Office Action Summary

10/572,611

DETAILED ACTION

FIG. 8

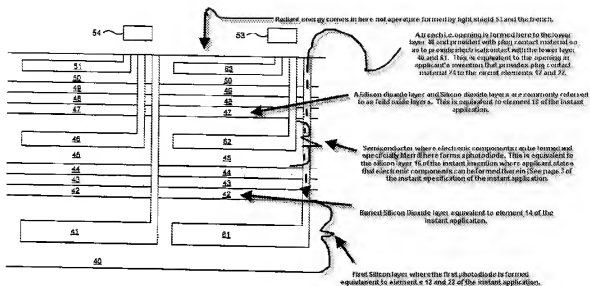
Figure 8 and the relevant text of Merrill disclose a silicon on insulator (SOI) photodiode and method of forming a SOI photodiode. The basic structure of the photodiode of the instant application is that of a common stacked multiple color photodetector. While the present applicant hints at the filtering, controlling the depth of the layer or layers, etc., this basic structure of the invention applies the well known (conventional) principles of stacked multiple color detectors. What happens in a stacked photodiode multiple color photodetector is that the higher frequency light signals (Sometimes referred to as "higher energy" light signals by some because of $h \cdot \nu$) gets absorbed quicker than the lower frequency light components, so the upper detector(s) detect the higher frequency component(s) like blue and as these higher frequency components like blue are all absorbed before they reach the lower frequency light detecting components like red. (See for example see the Figure illustrated on the cover of Merrill '050 and note that Merrill '050 is as only being cited to further emphasis this well known and common principle in stacked photodiode multiple color detectors.) In the actual Merrill reference applied herewith as rejecting the disclosed structure and associated method of forming the structure, filters like 43 and 48 are also used to ensure that the higher frequency components do not reach the lower frequency detector(s). As also noted in the original disclosure of the instant invention electronic components can be formed in the layer 16 of the instant invention and it is a fact that a p-n diode that detects light energy is an electronic component (See page 3, around line 21 of the instant application.). So while the instant application does not hint at stacked photodiode photo-detectors, (The addition of such in the original

The invention of Merrill discloses a silicon substrate 40 that is formed having a first portion doped "p" and the second portion 61 doped "n". This clearly forms a p-n junction and since the junction has both vertical and horizontal components, this can't help but have a "vertical pn junction". The silicon dioxide layer 42 forms a buried oxide layer and is clearly formed on the silicon substrate 40. There is a silicon layer 45 that is formed on the buried oxide layer. The functional language "wherein the amount of incident light passing through the SOI photodiode to the silicon substrate with respect to wavelength is proportional to a thickness of the silicon layer" does not add anything to the claim(s) for as stated above this is just an inherent property of the arrangement. It is the whole principle upon which stacked photodiodes work. The layer 47 that is formed on the silicon layer 45 being of silicon dioxide is a "field oxide layer". Silicon dioxide material is what is commonly referred to as a field oxide layer. The function of "wherein a thickness of the field oxide layer controls the thickness of the silicon layer" is like the functional language above that does not add anything to the claimed invention as stated above as this is just an inherent property of the arrangement. It is the whole principle upon which stacked photodiodes work. The "plug contacts" are formed in "trenches" that extend to the silicon substrate and it goes without saying that a contact is formed in the trench otherwise "plug contacts" would have a different name. Also note that Figure 15G of Merrill specifically calls the opening to the lower layers of a stacked arrangement a "trench". The examiner must read terms broadly with their plain meaning when applicant does not provide a specific definition that is different from the plain meaning of the term, i.e. a definition that defines something as something and only that something and that something is different from the plain meaning of the term. Thus if applicant wanted the term "trench" to designate some other structure than the plain meaning of the term as evidenced by even Merrill himself, then in accordance with recent case law to Halliburton Energy Services, Inc. v M-I L.L., Fed. Cir., 2007-1149 Halliburton decision the court says **"We note that the patent drafter is in the best position to resolve ambiguity in the patent claims, and it is highly desirable that the patent examiners demand that applicants do so in appropriate circumstances so that the patent can be amended during prosecution rather than**

With respect to claim 14, the doping of layer like 61 has to occur prior to the forming of the contact. Note that contact plug includes the metallization on the top thereof. Also note Figures 15E to 15H of Merrill here the doping of the "lower" layer 41 is provided, i.e. is formed before the trench is formed and then after the trench is formed the contact material is formed in this trench to form this "plug contact" to the lower layer. Same claimed structure and method of manufacture as disclosed and claimed is clearly disclosed by Merrill, i.e. applicant forms the lower layer 12 first and then provides an opening to the lower layer 12 and then forms a plug contact 24 to the lower layer 12 so that this lower layer is electrically contacted to the outside world.

With respect to claim 12, the contact in combination with the light shield 53 forms i.e. defines "an" aperture of the SOI photodiode. Note that there can be other apertures and the claims do not exclude other things as defining an aperture.

Note the following additional comments are made to help in the furthering of the prosecution of the instant application and help guide applicant to form an allowable amendment should applicant decide to amend the application. Applicant may try to amend the claim to state that the instant invention does not include a third silicon region similar to that of region 50 in Merrill, but applicant should take note that it has long been established in case-law that the elimination of something along with the elimination of that feature/function is generally obvious. So clearly to make a two color detector one would drop the top detector of a three detector device. That would be one way to do it that lies within routine skill in the art.
